V2500-A1/A5/D5 SERIES PROPULSION SYSTEMS SERVICE BULLETIN

This document transmits the Initial Issue of Service Bulletin V2500-ENG-72-0613.

ENGINE – HIGH PRESSURE (HP) COMPRESSOR – INTRODUCTION OF A NEW HP COMPRESSOR REAR  
SHAFT ASSEMBLY WITH A RING NUT THAT IS SILVER PLATED ON THE THREAD AND ABUTMENT FACE  
TO THE CUP WASHER ONLY AND NUTS WHICH ARE SILVER PLATED ON THE THREADS ONLY

Rework details and dimensions  
Figure 1

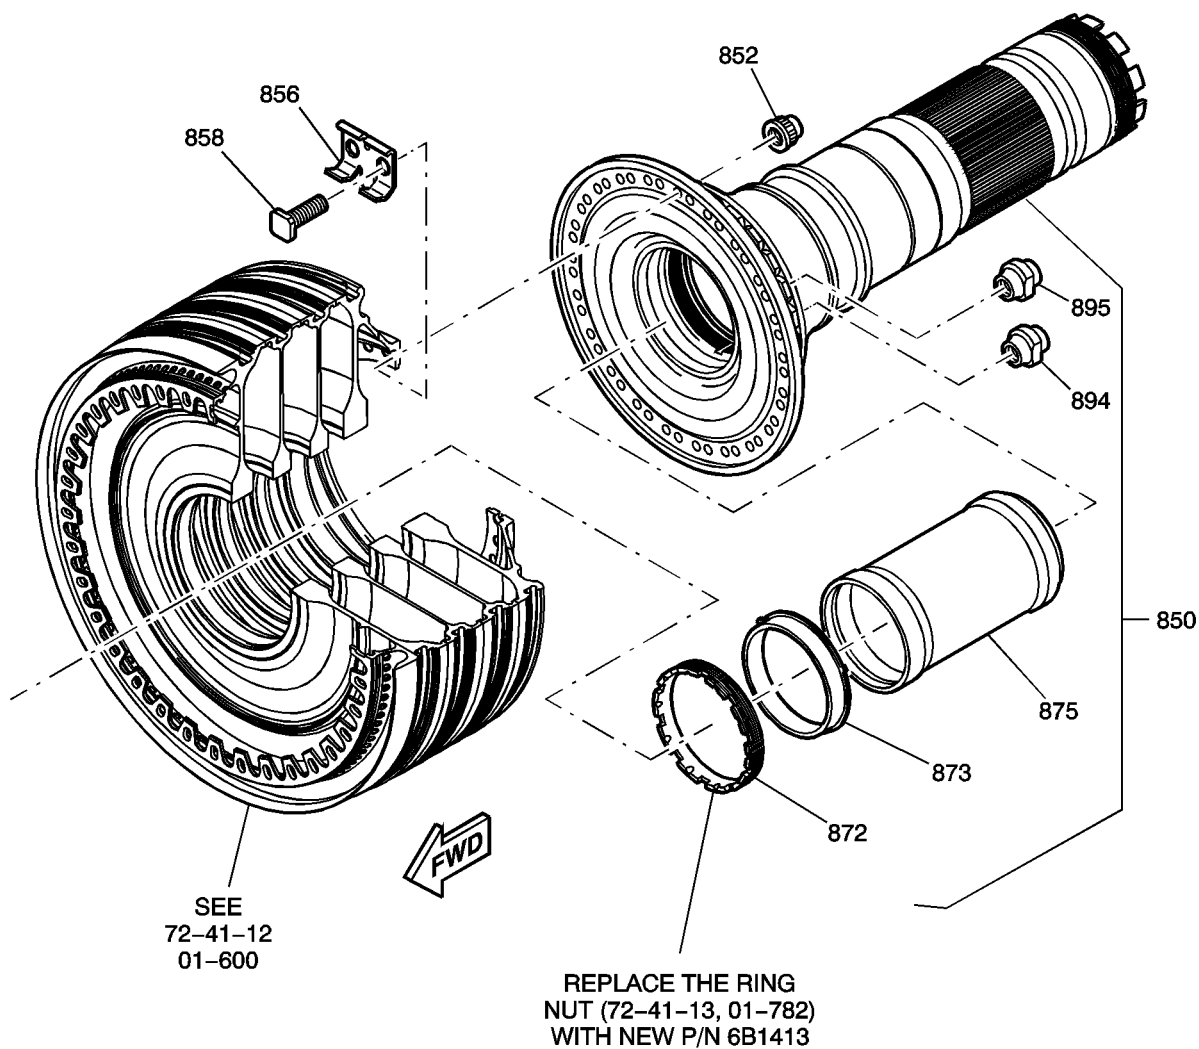
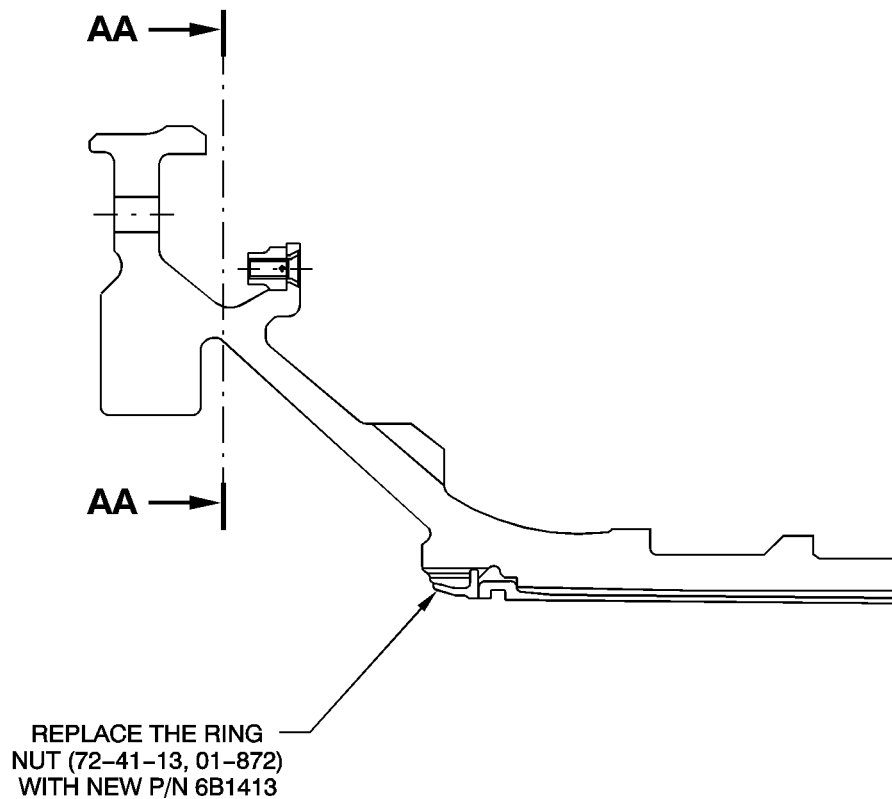
- (i) To replace all 36-off self locking nuts located on the bolting flange for the rear air seal. Parts to be replaced are AS27853 and AS27857 self-locking shank nuts with new AS63483 and AS63487 self-locking nuts, respectively.
- (ii) To replace the Ring Nut located in the inner bore of the rear shaft. Part number UP10896 is to be replaced with new part number 6B1413.

(a) Refer to Figure 1.

Refer to EM TASK 72-41-13 HP Compressor Shaft - Disassembly, accomplish all SUBTASKs therein. Remove the Ring Nut (72-41-13, 01-872) part number UP10896 and discard.

- (a) Fit new ring nut 6B1413 into the shaft assembly.

Refer to EM TASK 72-41-13 - Assemble the HP Compressor Rear Shaft Assembly, accomplish all SUBTASKS therein.  
Install the new Ring Nut (72-41-13, 01-872) part number 6B1413. Ensure the old Ring Nut UP10896 is not used.

Rework details and dimensions  
Figure 2

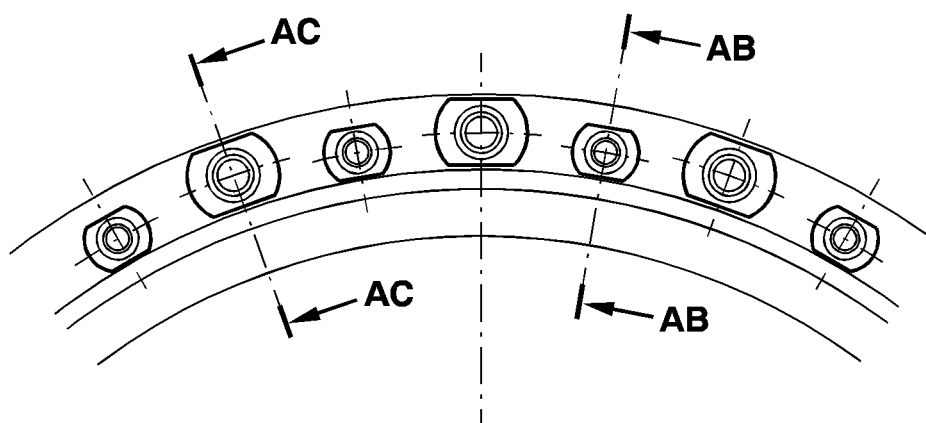
(a) Refer to Figure 1, Figure 2 and Figure 3.

(b) Drill the flare section AB, until the nut is released.

Refer to SPP TASK 70-35-11-300-501. Use a drilling machine with a 0.220 in (5.60 mm) diameter drill.

(c) Drill the flare section AC, until the nut is released.

Refer to SPP TASK 70-35-11-300-501. Use a drilling machine with a 0.315 in (8.00 mm) diameter drill.

- (b) Install new nuts into their respective location holes.

Use self-locking shank nuts – AS63483 Qty 18 and AS63487 Qty 18. Make sure the shank nuts are installed correctly into the correct holes.

- (c) Hold the nut and swage the flare.

Use IAE 3R19066 (tool bolt) 1 off and IAE 3R19067 (swage bush) 1 off and/or IAE 3R18718 (tool bolt) with IAE 3R18737 (swage bush) 1 off.

Rework details and dimensions  
Figure 3

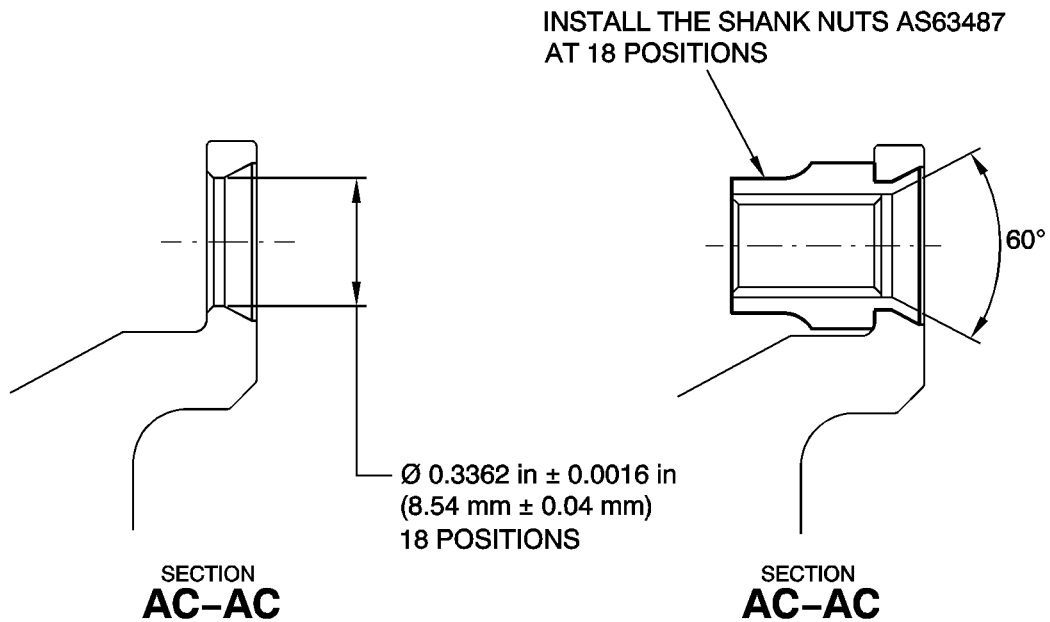
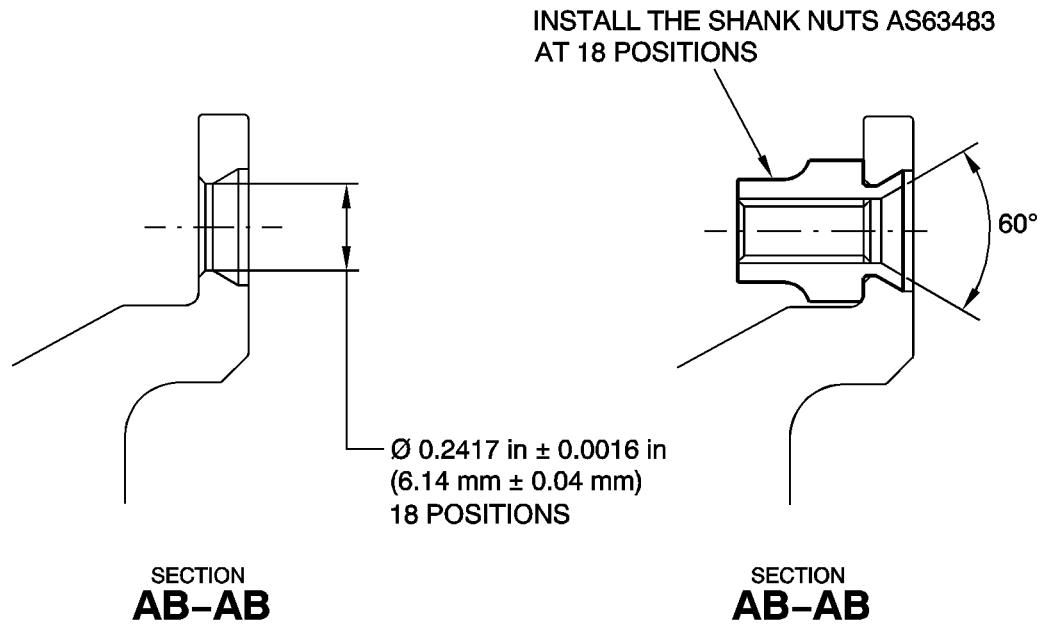
(a) Refer to Figure 1, Figure 2 and Figure 3.

(b) Visually examine and check the dimensions of the nut location holes.

Ensure all dimensions are within the limits shown.
